NRC RAI Letter No. PTN-RAI-LTR-047

SRP Section: 02.04.06 – Probable Maximum Tsunami Flooding

NRC RAI Number: 02.04.06-7 (eRAI 6225)

Figure 2. Outline of maximum credible submarine slide above the Florida Escarpment, developed from multibeam bathymetric data (Source: Reference 7).

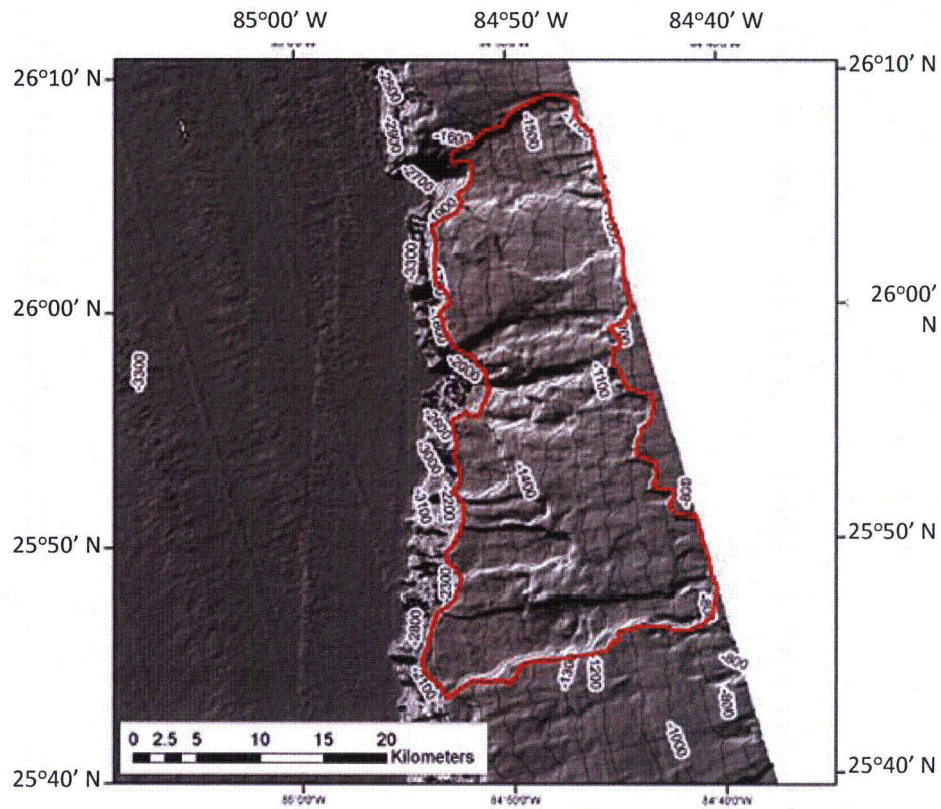
To meet the requirements of GDC 2, 10 CFR 52.17, and 10 CFR Part 100, FPL should provide an assessment of the Probable Maximum Tsunami (PMT) for the proposed site. Section C.I.2.4.6.3 of Regulatory Guide 1.206 (RG 1.206) provides specific guidance with respect to the source characteristics needed to determine the PMT. Provide justification that triggering conditions for submarine mass failures in the Florida Straits are not currently present. If triggering and pre-conditioning factors/loading conditions such as those that caused the Miocene debris flows and likely Pleistocene-age failures at the western end of the Florida Straits (Holmes, 1985; Twichell and others, 1993) cannot be determined, explain whether potential submarine mass failures can be conservatively excluded. If such failures are considered, discuss how inclusion of this source affects PMT water levels at the site.

The area that is postulated to be the site of a maximum credible submarine landslide is identified along the southern part of the West Florida Slope as delineated in Figure 2 (Reference 7). Doyle and Holmes (Reference 4) and Twichell et al. (Reference 5) have stated that this area has undergone collapse. The area is described as characterized by "scarps (that) are still exposed on the seafloor and have 50-150 meters relief and are 10-70 kilometers in length" (Reference 7). According to ten Brink et al. (Reference 7), "some of the mass movement deposits are on the slope above the Florida Escarpment, but it is unknown how much of the failed material was transported farther and deposited at the base of the Florida Escarpment." These landslides from the West Florida Slope are composed of several smaller failure events as seen in the cross cutting relationships of the headwall scarps in the imagery (Reference 5). The age of these failures is not known, but it is suggested by Mullins et al. (Reference 3) and Doyle and Holmes (Reference 4) that periods of increased mass wasting are associated with periods of higher sedimentation rates. Therefore, it is possible that the landslides along the southern part of the West Florida Slope are likely early Holocene (4500-10,000 years before the present) or older in age (Reference 6). The runout distance of the existing slope failure is uncertain, as landslide deposits at the base of the West Florida Escarpment are buried under younger Mississippi Fan Deposits (Reference 7).
